Wiltshire Council Housing Site Allocation Plan Examination – Site 2.4 Church Lane

Matter 3: Housing Site Allocations

Figure 6 Core bat habitat feature and associated buffer zone

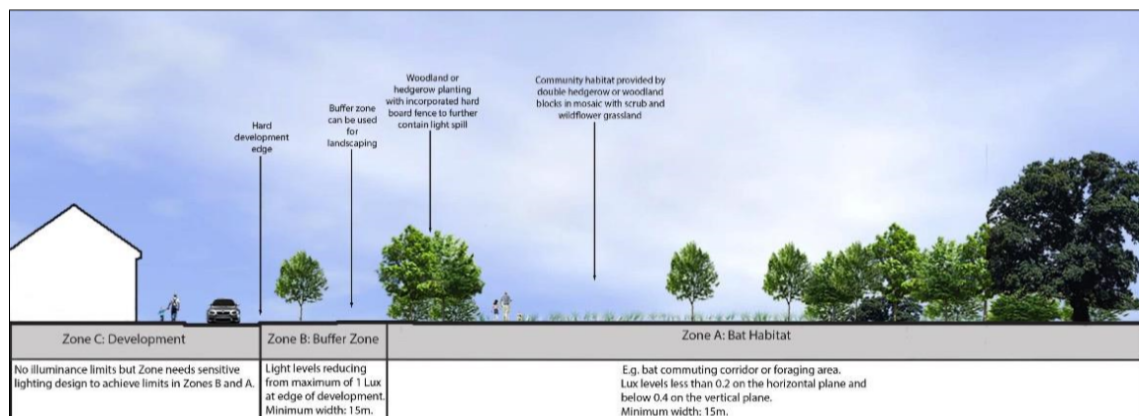
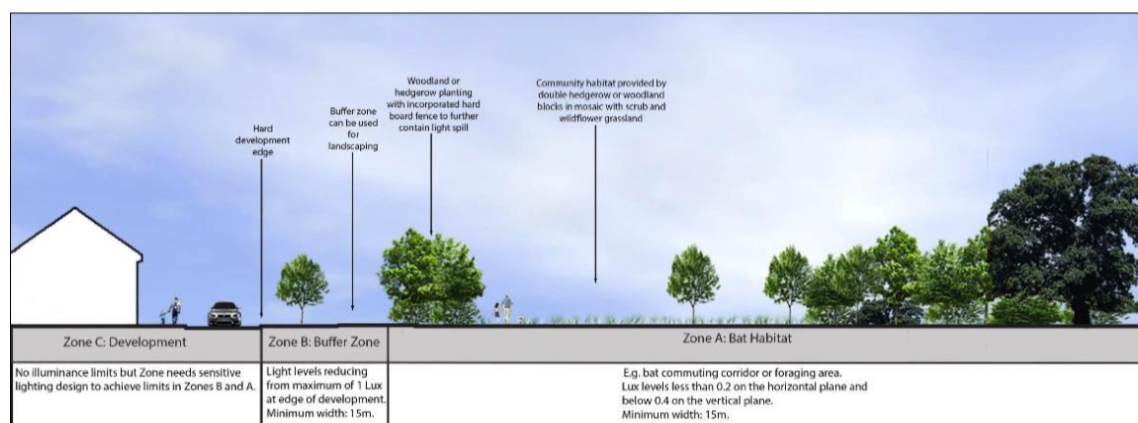
1. Site 2.4 is lies within a Yellow Zone, identified as of Medium Risk with regards to bat flight paths, commuting and foraging routes and as such should be protected by suitable mitigation.
2. Hedgerows, especially ancient hedgerows should be maintained and protected **and** infilled where gaps have been made.
3. A **MINIMUM** of 15m dark bat habitat (in public ownership) should be put in place **PLUS** a further 15m buffer zone (soft landscaping) before any hard development should take place. See example diagram below.

In addition, the WHSAP states that a bat corridor of 10m-15m should be provided as mitigation. This is clearly not in line with the recommendation made in The Draft Trowbridge Bat Mitigation Strategy. In fact, the recent planning application for Site 2.4 only provides a 10m bat corridor (see Planning application 18/10035/OUT).

A **MINIMUM** of 15m dark bat habitat (in public ownership) should be put in place **PLUS** a further 15m buffer zone (soft landscaping) before any hard development should take place. See example diagram below.
